**CITY OF MERCER ISLAND
DESIGN COMMISSION
FINDINGS OF FACT AND CONCLUSIONS
OF LAW**

**Agenda Item: X
May 16, 2024**

Project:	Monaco Villa Condominiums Repair and Remediation (DSR24-002)
Description:	A Design Commission Design Review application to repair and remediate the Monaco Villa Condominiums. The scope includes the removal of all damaged and failing existing siding at the north, east, and south elevations. The architectural massing would also be improved as part of the repair.
Applicant:	James Ramil and Tess Cleary (Evolution Architecture) for Joe Peloso (Monaco Villa Condominiums Property Manager)
Site Address:	2929 76th Avenue SE, Mercer Island WA 98040; Identified by King County Assessor tax parcel number 5569600000
Zoning District:	Multiple Family (MF-2)
Exhibits:	<ol style="list-style-type: none">1. Design Review Plan Set, dated January 24, 2024 prepared by Evolution Architecture2. Project Narrative3. Study Session Notes

UPDATED DESIGN
USING COMMENTS

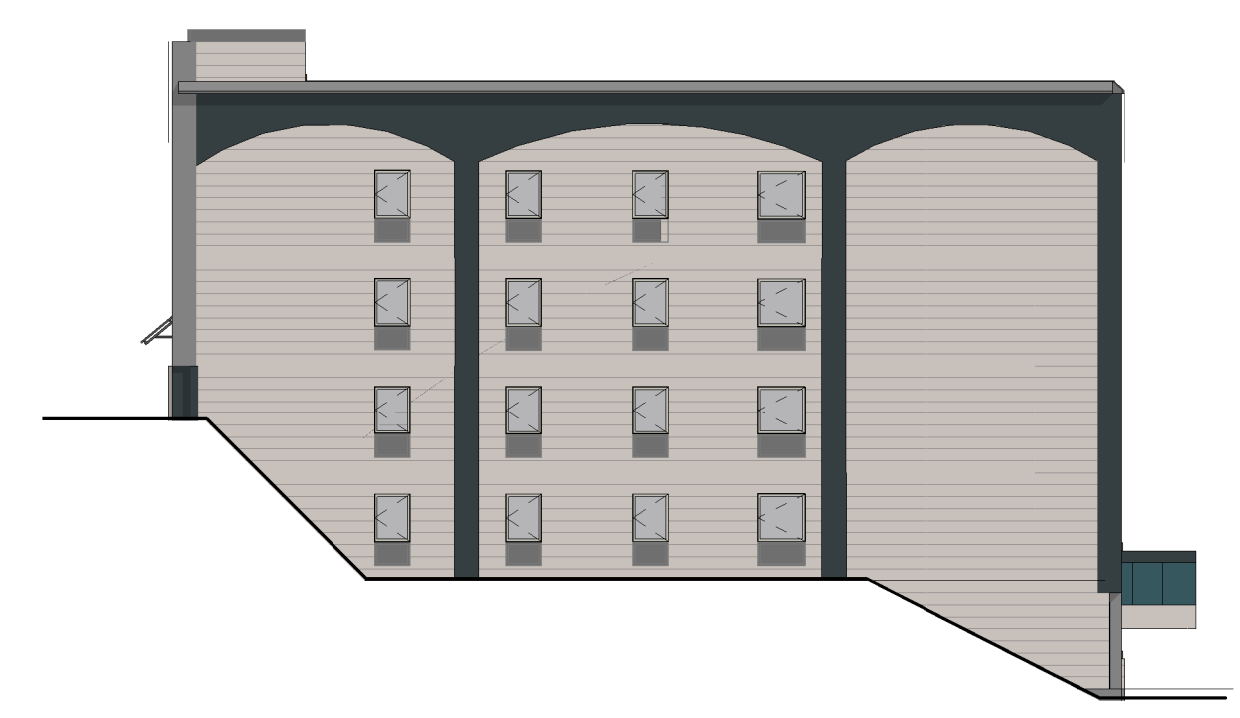
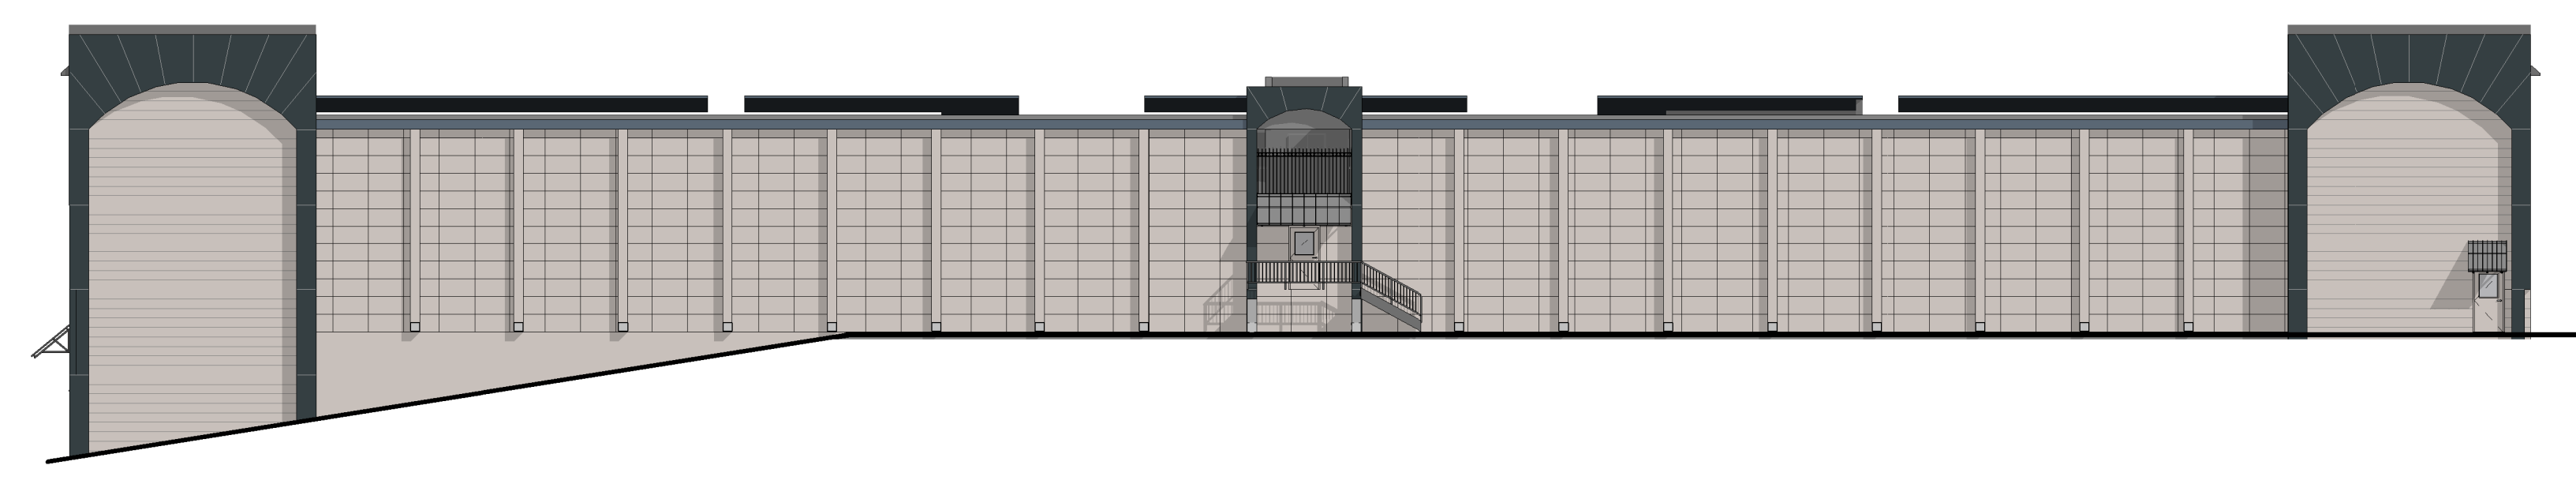
- Materials –
 - Trespa seems to be a flat material and presents in one face (timestamp 1:23:40)
 - The amount of Trespa on the front elevation makes the material look not as high quality (timestamp 1:28:10)

**ENLARGED AERIAL
VIEW**

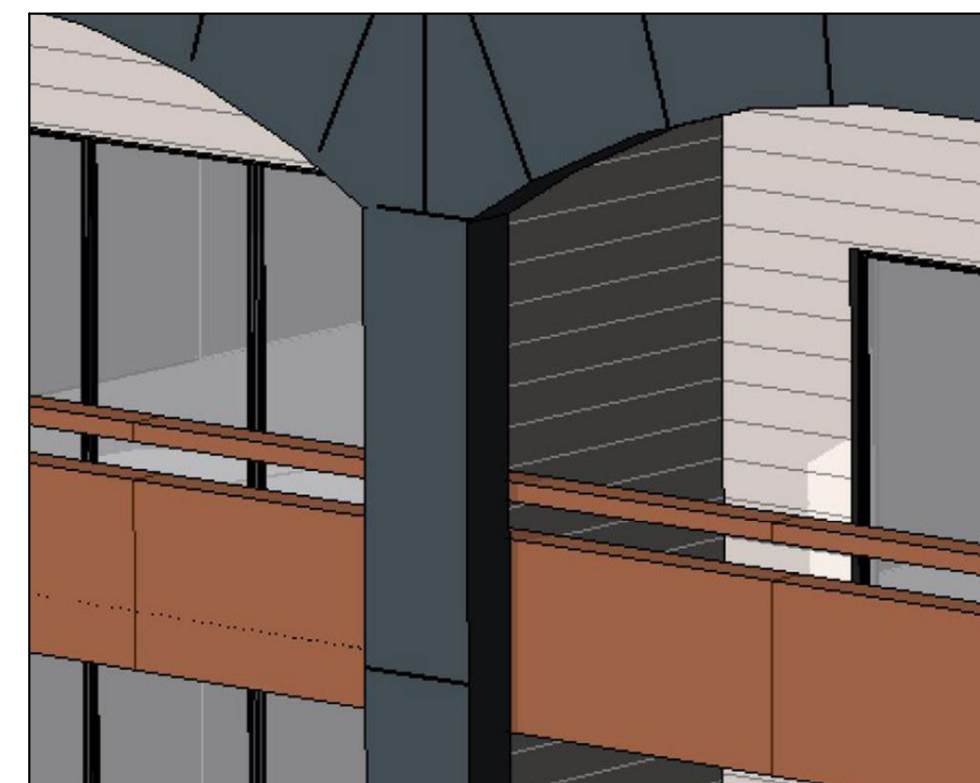
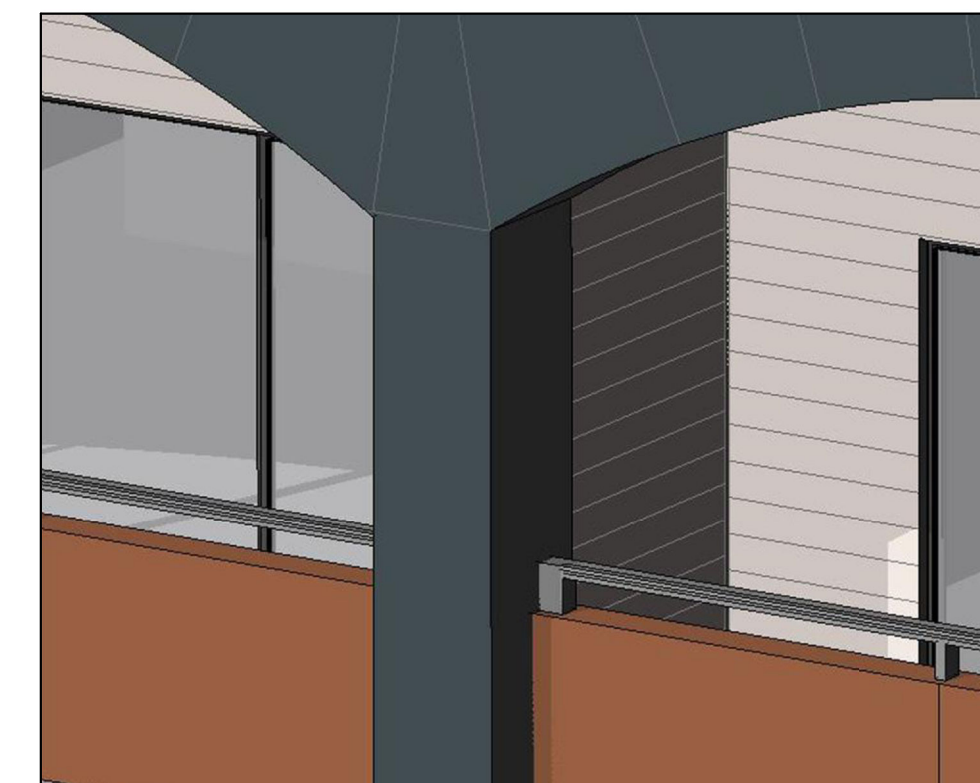
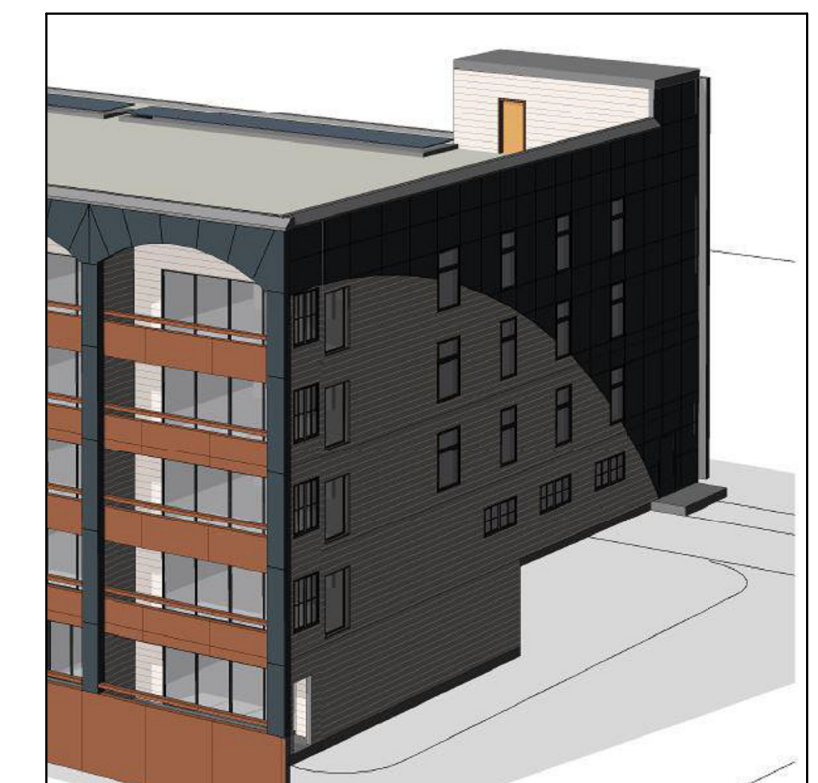
- Facade feels “paper thin”. The existing arches feel more monolithic and monumental, and when they are broken up with the hardy reveals, they start to feel thinner in materiality. Suggestion to turn the corner with the material (timestamp 1:30:41)

- Super graphics –
 - How is the classical architecture of the building interpreted with the super graphic? (timestamp 1:25:00)
 - Existing foliage at the ends of the building gives more license to have a cleaner and simpler design due to the wall acting as a backdrop to the trees (timestamp 1:26:53)

ORIGINAL ENTRY CANOPY WRAPPED
IN TRESPA

ORIGINAL COLUMN TREATMENT
APPEARED SOMEWHAT SHALLOW

UPDATED COLUMN TREATMENT READS AS
MUCH MORE SUBSTANTIAL

ORIGINAL END FACADES TREATED IN A
SUPER GRAPHIC

UPDATED ENTRY CANOPY
WRAPPED IN COPPER REUSED
FROM THE CURRENT BUILDING

UPDATED END FACADES
MIRROR EAST FACADE
RHYTHM AND SCALE
